15 December 2025

**RE: Response to public comment received for the Goyder North Wind Farm
Preliminary Documentation (EPBC 2024/09929)**

Figure 4.1 INTG Impacted by the Disturbance Footprint Across the Project Area (1 of 2)

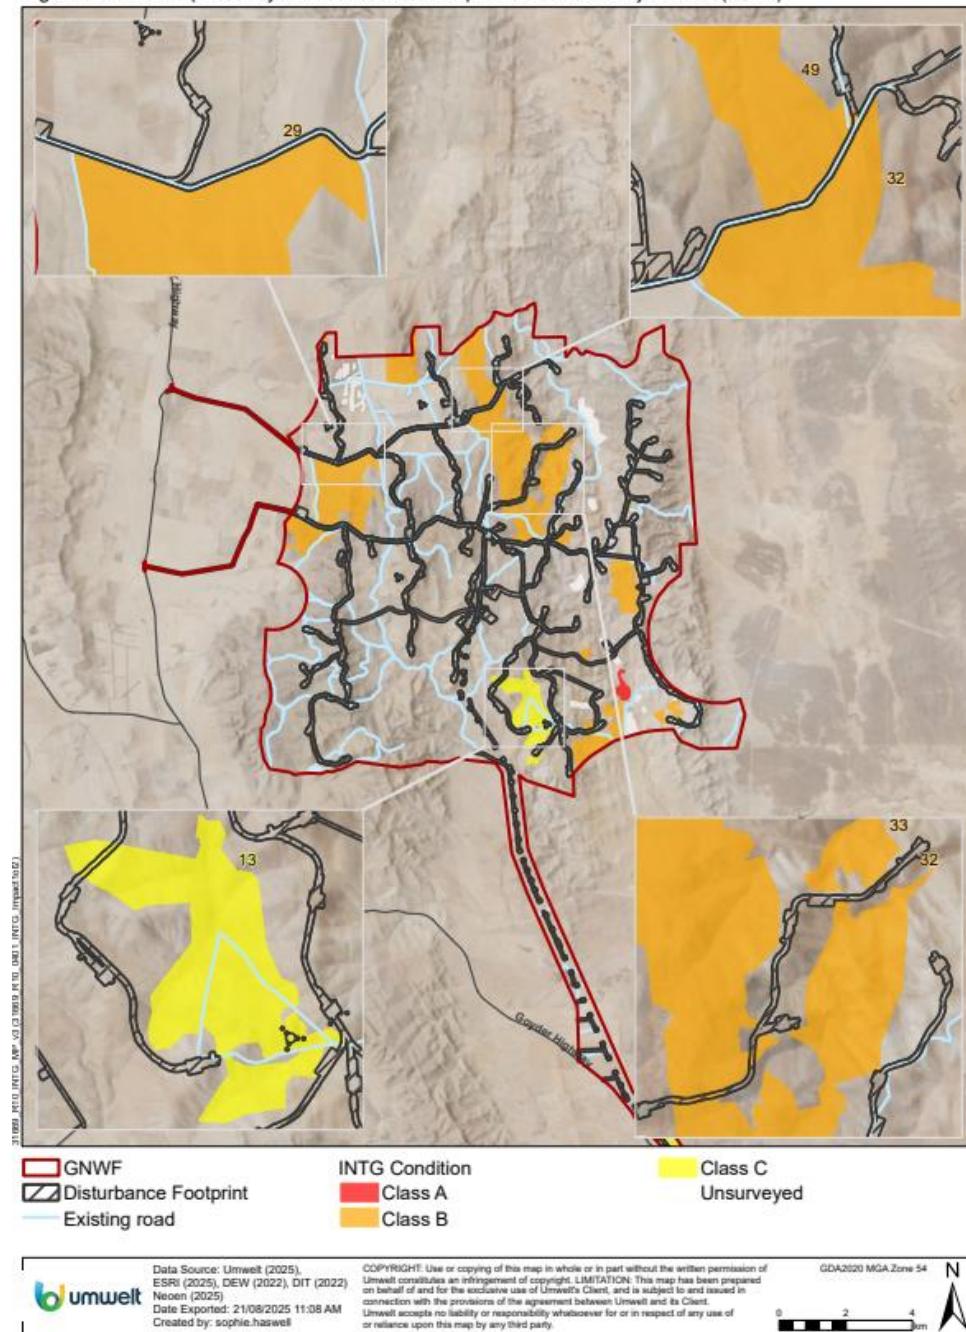
Table 2 (page 21-24) of the September 2025 report describes the local context of patch impact from the development layout. There are 12 locations identified, of which 3 are of interest – Site ID 51, Site ID 24 and Site ID 32:

Site ID 51 – the hard stand will cut the corner of a highly diverse patch containing two vulnerable species from the SA state list. It is asked if there is potential to microsite this hard stand to avoid this direct impact.

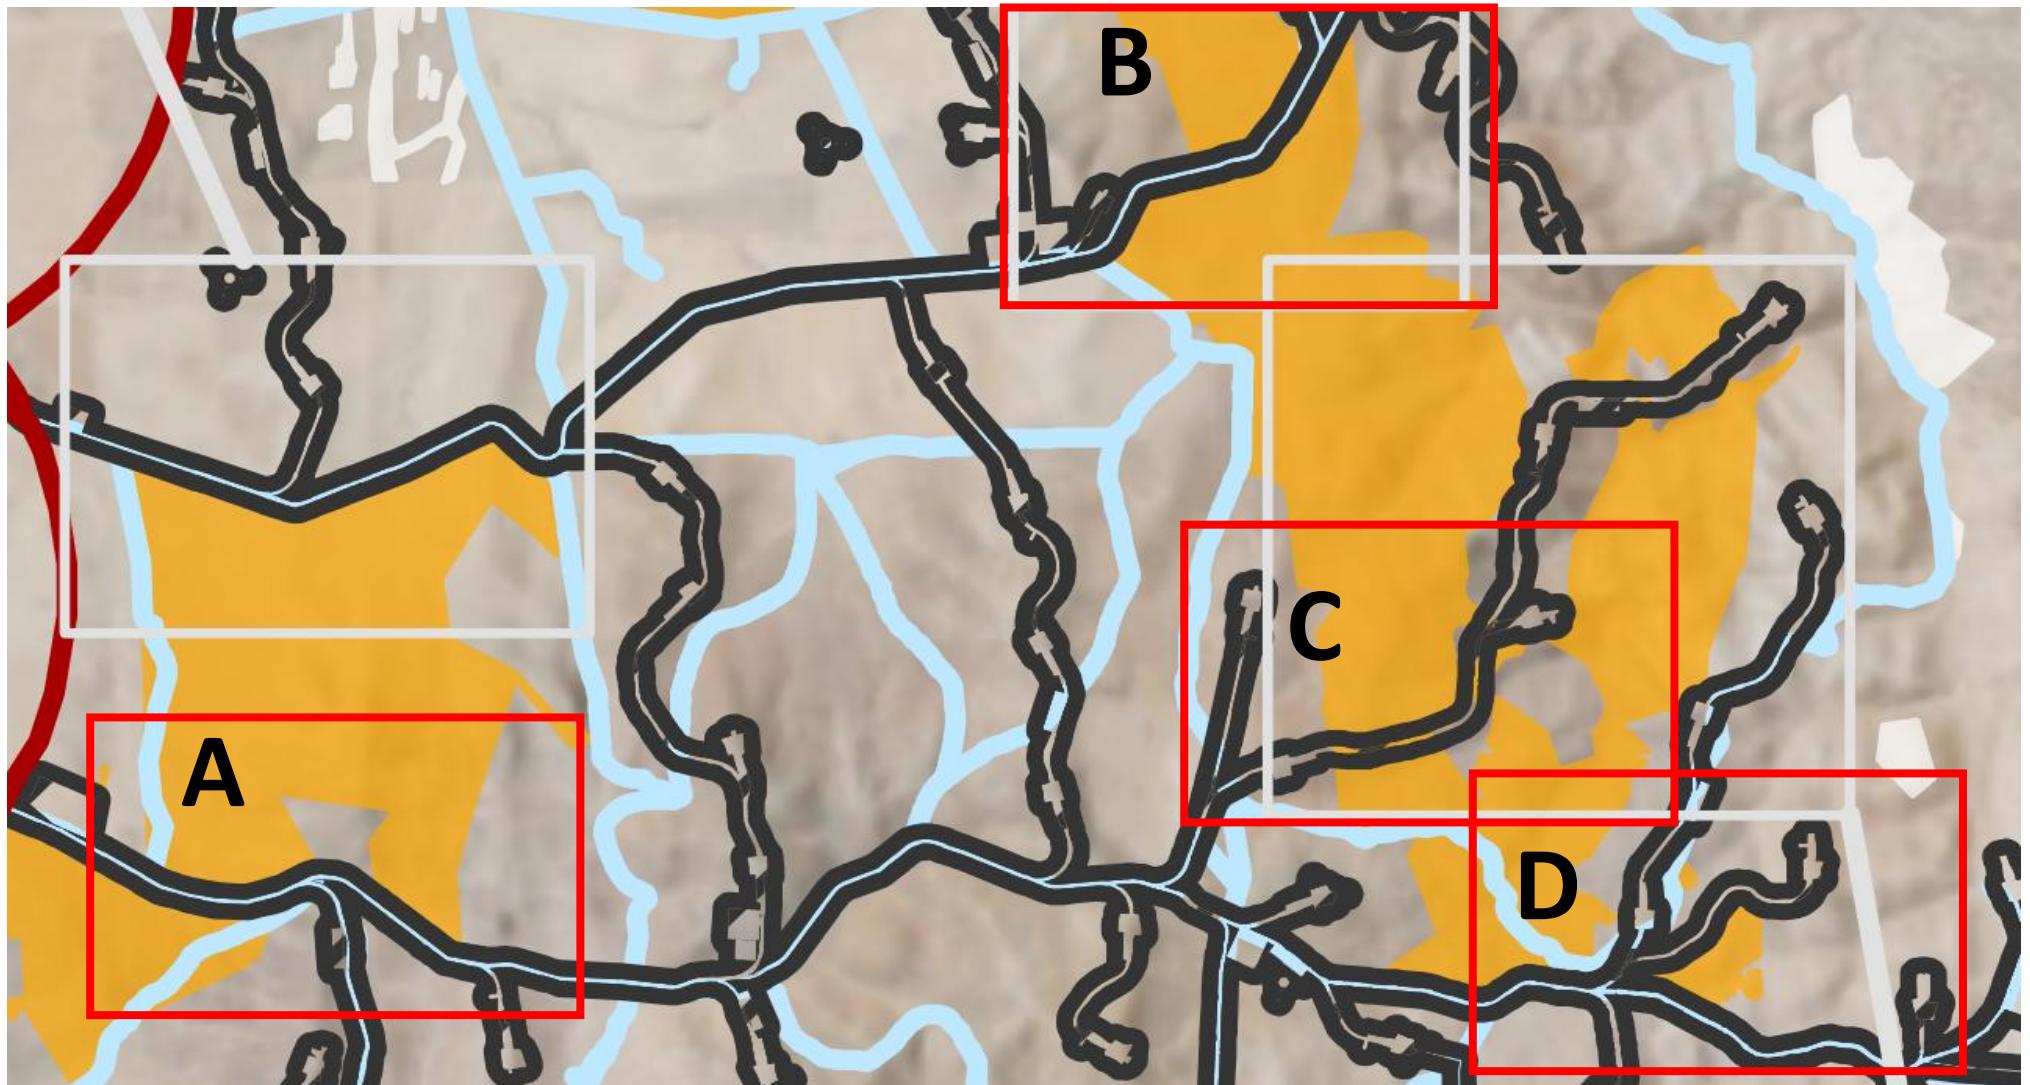
1. Mokota CP – this protected area is impacted on both the north and south boundary by the proposed access roads (see Area A in Figure 1). It is not clear why there needs to be two access tracks into the windfarm, when one may be sufficient. The southern track has INTG TEC to the north in Mokota, and to its south. It is anticipated that many existing tracks may need widening, creating direct loss of INTG TEC. Even if tracks are not widened, they will still create an indirect loss through changes in hydrology, increased pest access and dust. Reducing the number of tracks would reduce the overall impacts on the INTG TEC.

2. Large central area of INTG TEC – this area has been assessed as Class B, while still experiencing grazing by sheep (see Areas A, B and C in Figure 1). An alternative route approaching turbines on the east of this area of INTG TEC on existing roads in the east would avoid the need to bisect this large patch (Figure 2). This alternative route would pass a patch of INTG TEC, not recently surveyed for this assessment and therefore would need to be surveyed to better understand the impacts of the alternative route proposed.

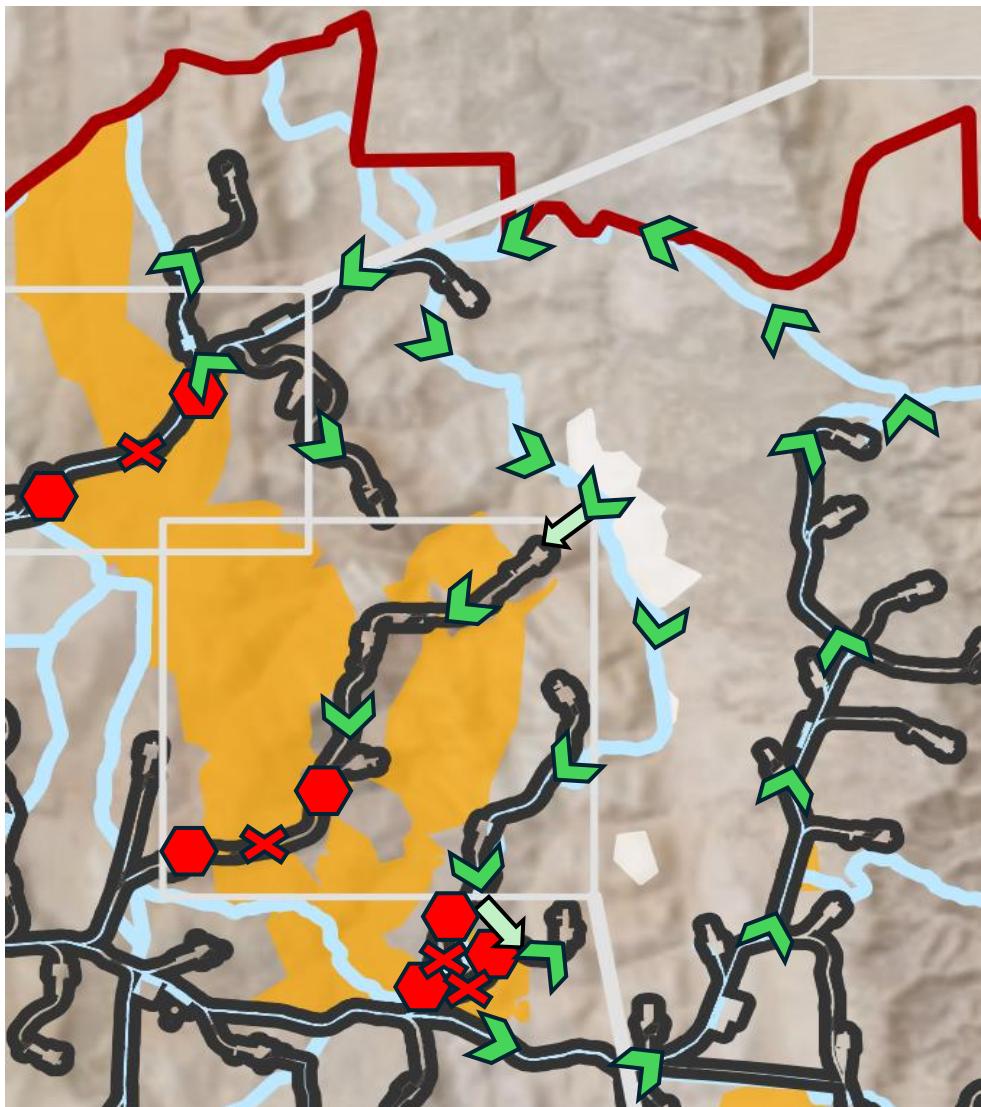
3. Large fragmented area of INTG – in the SE corner of site access tracks appear to be bisecting and isolating Class A, Class B and Class C INTG TEC (see Areas E and F in Figure 3). This is an ideal area for conservation and restoration work to improve INTG TEC. An alternative route is proposed for these sections, using existing access tracks to avoid direct impacts (Figure 4). In addition, two existing roads in the area could be closed for the life of the project to further assist conservation and restoration of INTG TEC.
